**STATE OF WASHINGTON
DEPARTMENT OF ECOLOGY**

USG Interiors, LLC
(Highway 99 Site)

FIRST AMENDMENT TO AGREED ORDER

No. DE 11099

FIGURE NO. 13
 PLANNED REMEDIAL EXCAVATION WSDOT P429 PLUS
 PROPERTY AND CREEK BED - CROSS SECTION VIEWS

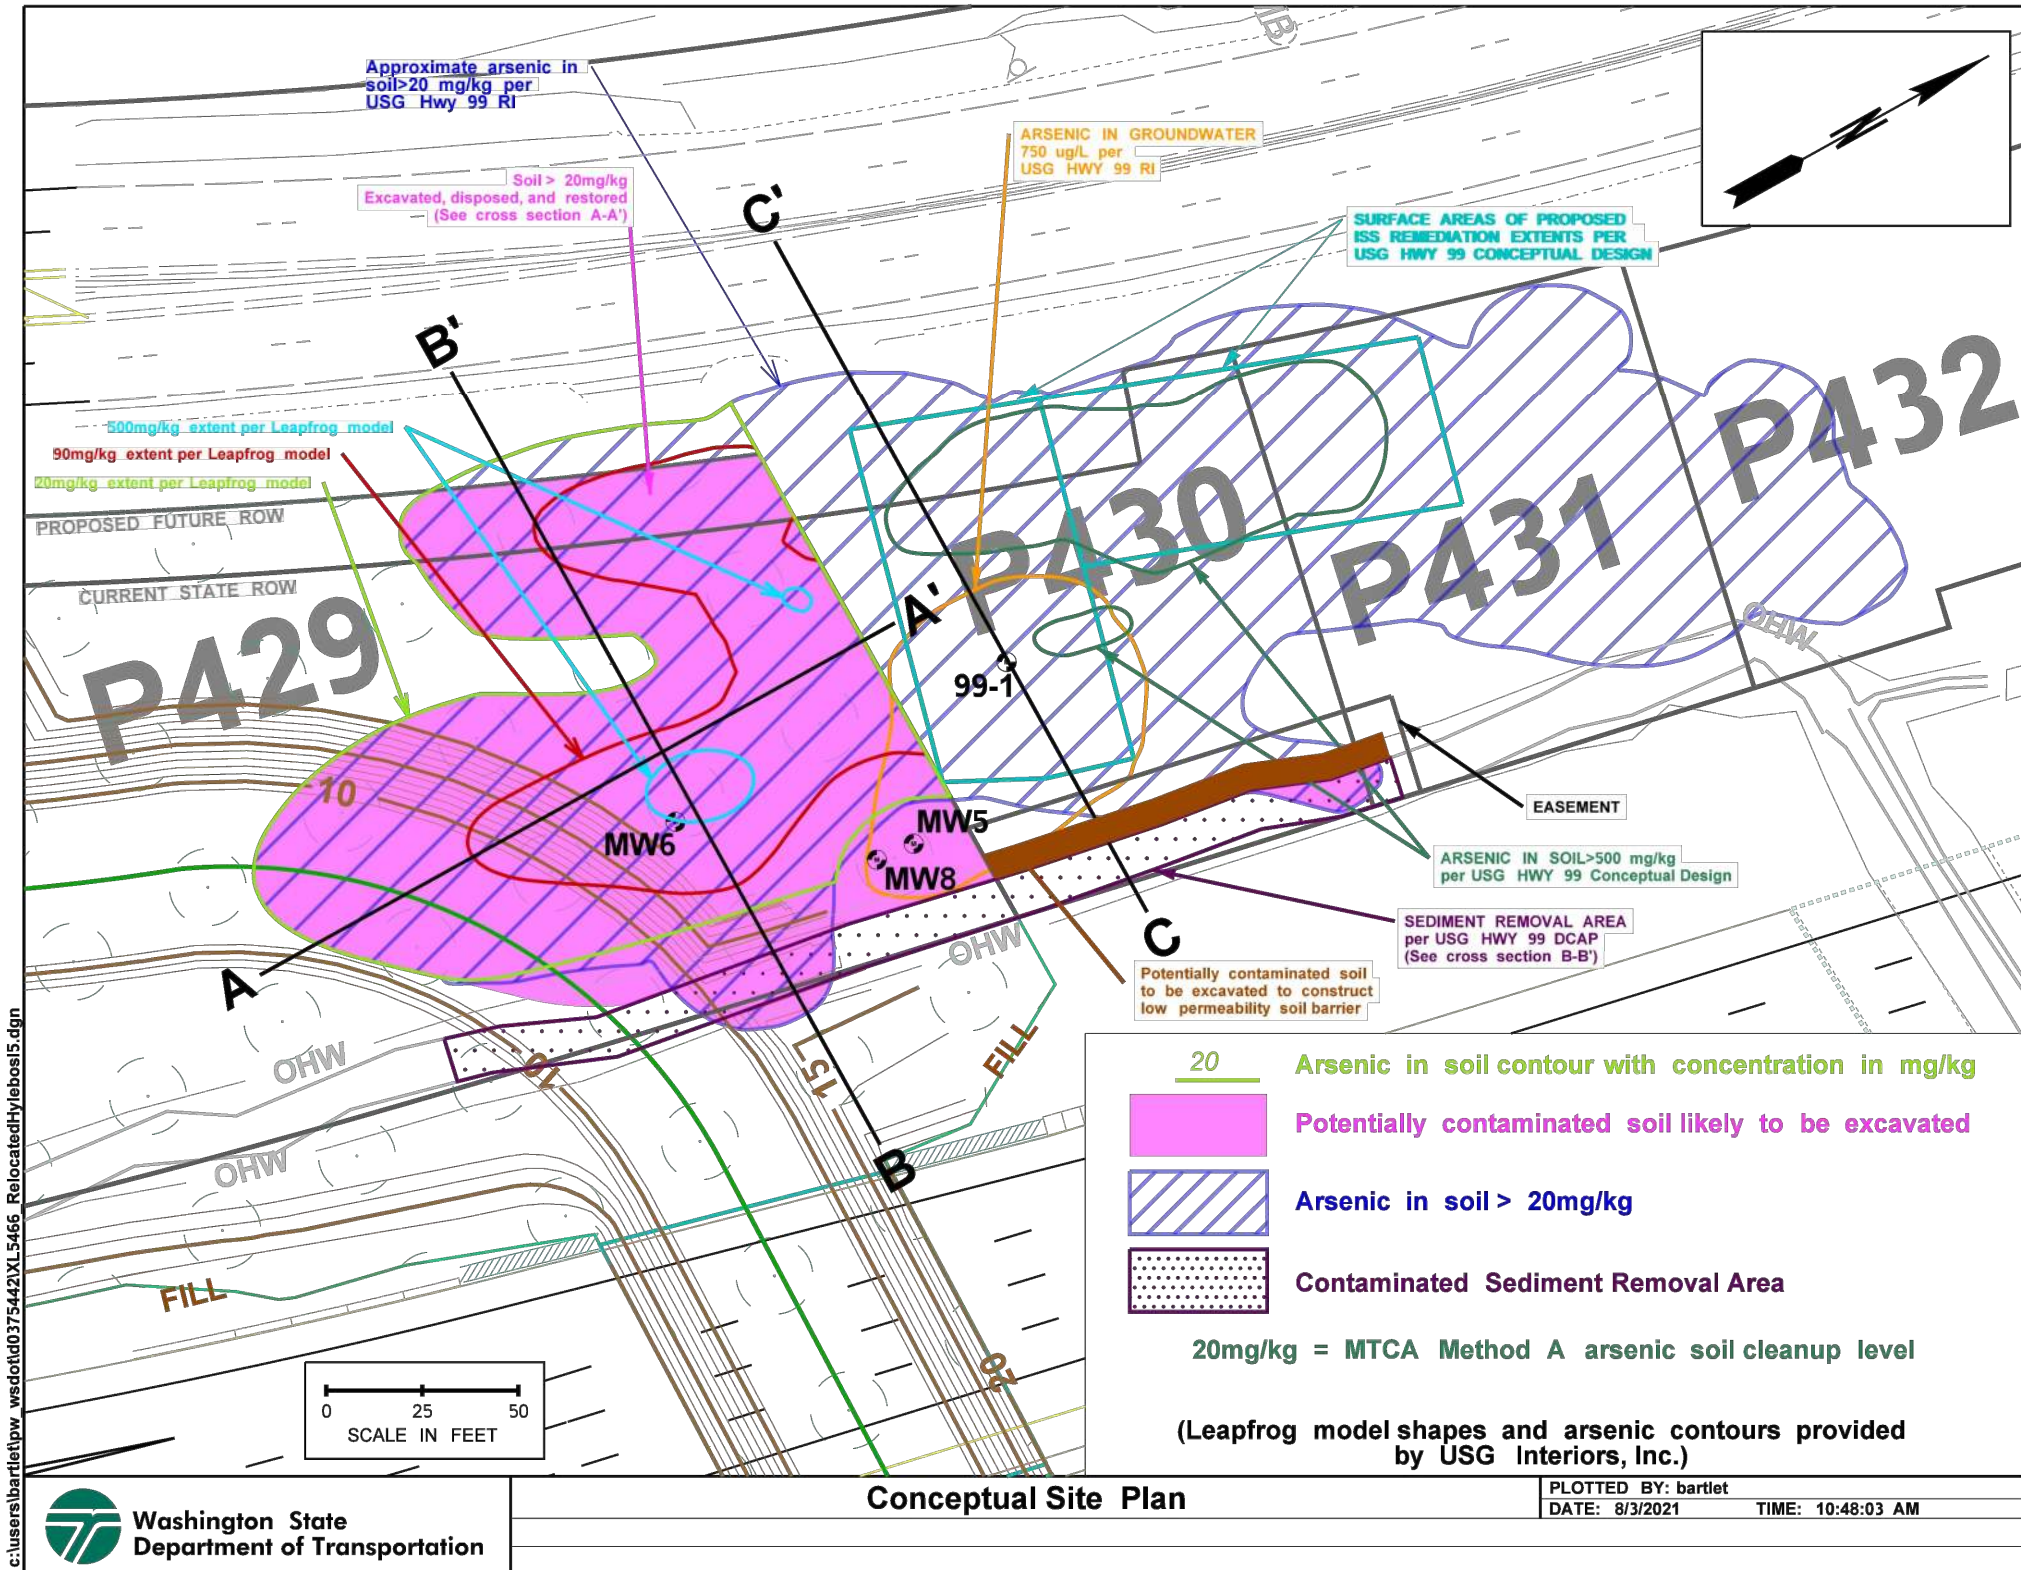
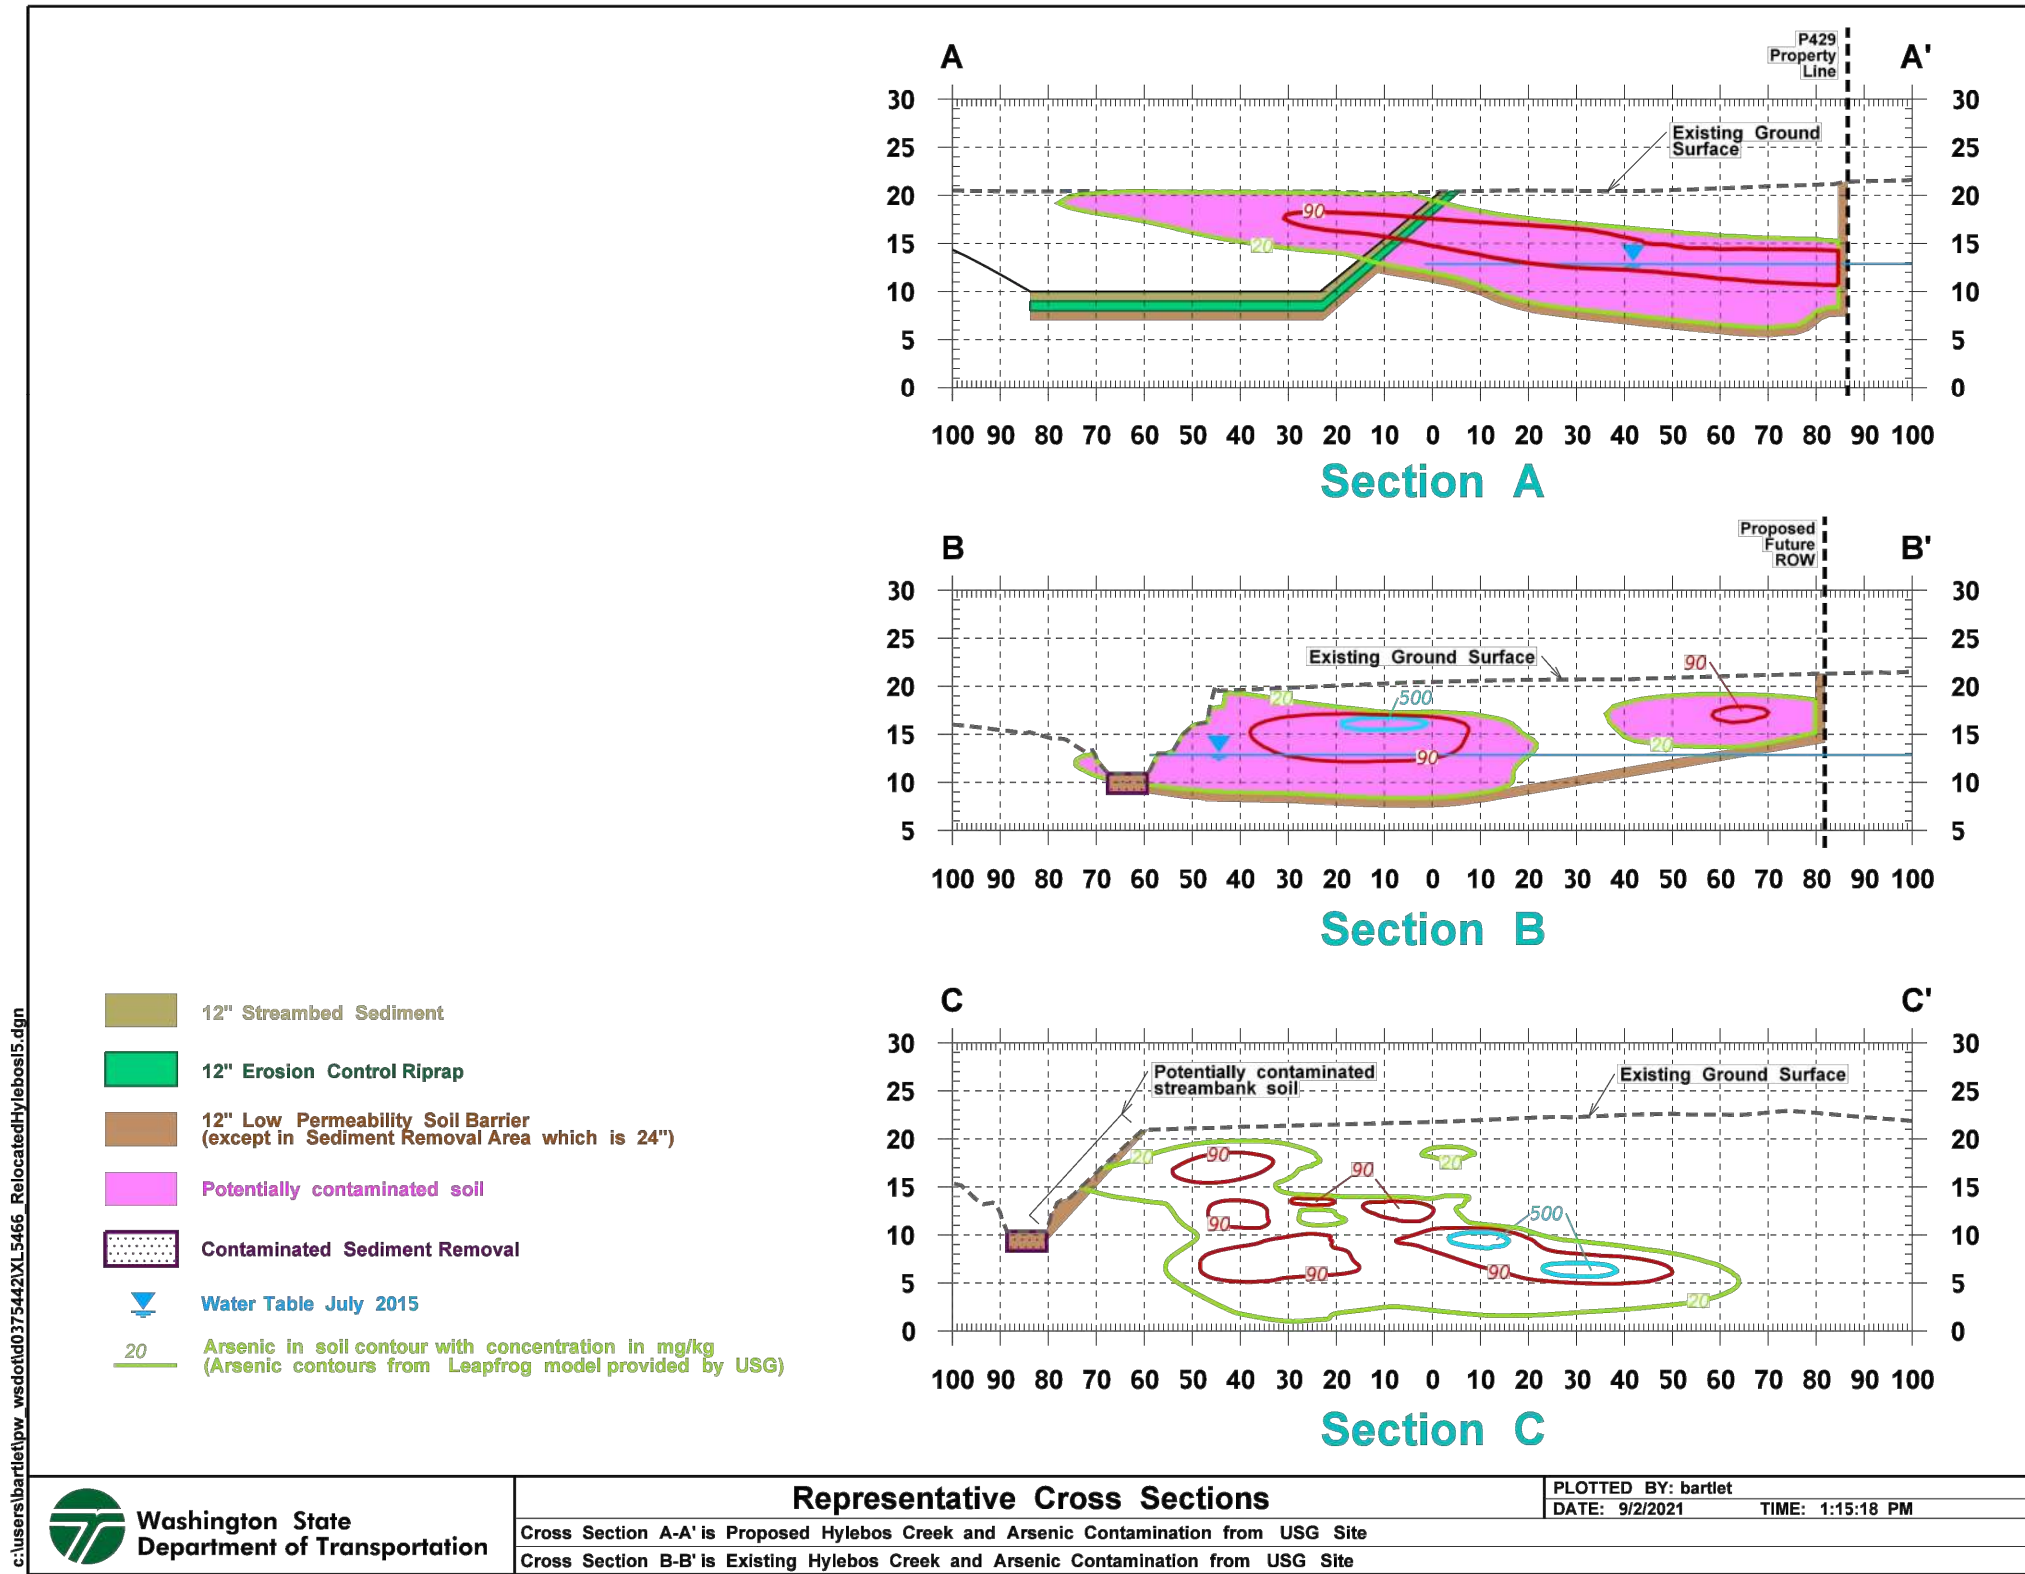
The other major modification to the remedial action is that soil excavation will occur on the adjacent WSDOT P429 Plus property. WSDOT plans to conduct excavation of all soils exceeding

Figures 12 and 13 show the plan view and cross section views of the anticipated remedial excavations.

FIGURE NO. 20
ALTERNATIVE 3: PROPOSED TREATMENT AREA
OF ARSENIC > 250 PPM IN SOIL - PLAN VIEW

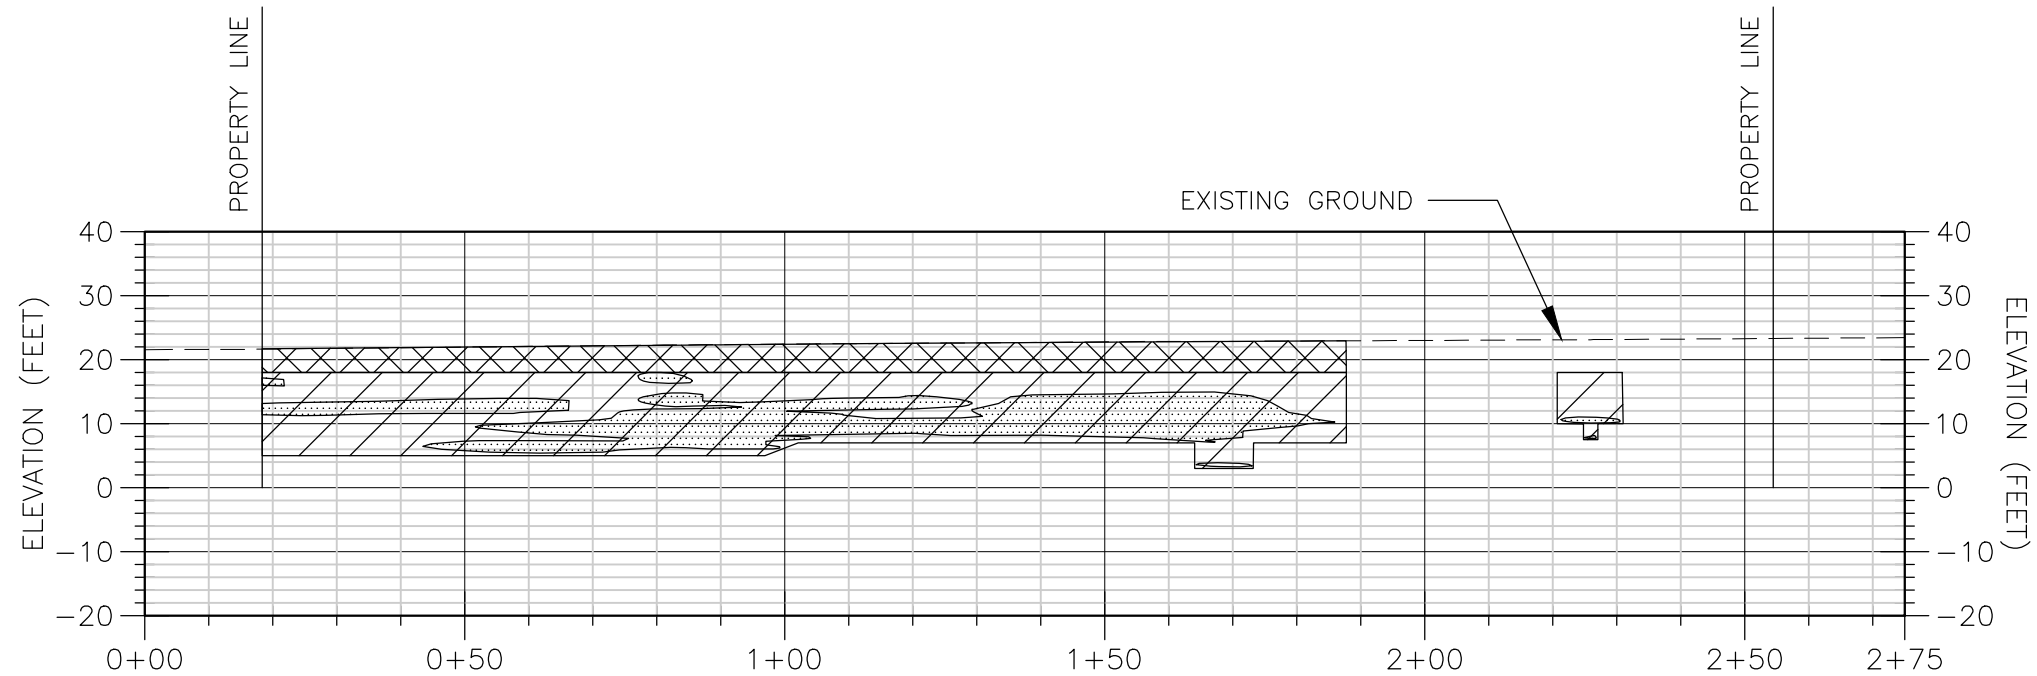
Based on the results of the DCA, Alternative 3 is the recommended alternative. The conceptual design for Alternative 3, treatment of all soils that exceed 250 mg/kg, is shown on **Figures 20** through **22**. At a minimum, the treatment area will be split up into four sub-areas to optimize the depths of treatment. **Table 7-1** presents the physical data for each of these treatment sub-areas including volume, top and bottom of treatment zone, and treatment zone thickness as proposed during the conceptual design. As is shown on **Figure 21** and indicated in **Table 7-1**, the top five feet of soils will be excavated and temporarily stockpiled onsite. These are the clean soils that were used as backfill during the initial remedial action. Once these soils have been excavated, mass stabilization by ISS treatment will commence using an excavator to place and mix in the admixture. The treatment area will be divided into multiple “cells” and the excavator will complete work in one cell before moving to another. After completing the ISS, the temporarily stockpiled soil will be used to backfill the remainder of the excavation. Excess soil is anticipated some of which will be used to nominally increase the site grade slightly; the remainder will be disposed of offsite.

The CAP is modified to include conducting In-Situ Solidification and Stabilization (ISS) to a greater depth in the Core Remediation Area, targeting all soils in the unsaturated and saturated zone exceeding 250 mg/kg arsenic based on modeling of arsenic concentrations in soils. The planned area of ISS will also capture nearly 85% of soils exceeding 90 mg/kg arsenic, and 35% of soils exceeding 20 mg/kg arsenic. Implementing ISS not only in the vadose soils, but also in the high concentration saturated soils should greatly improve groundwater quality. In addition, all of the soils that exceed 20 mg/kg arsenic on Parcel P429 and the adjacent right-of-way (Parcel P429 Plus) will be excavated and hauled off site to an appropriate disposal facility.
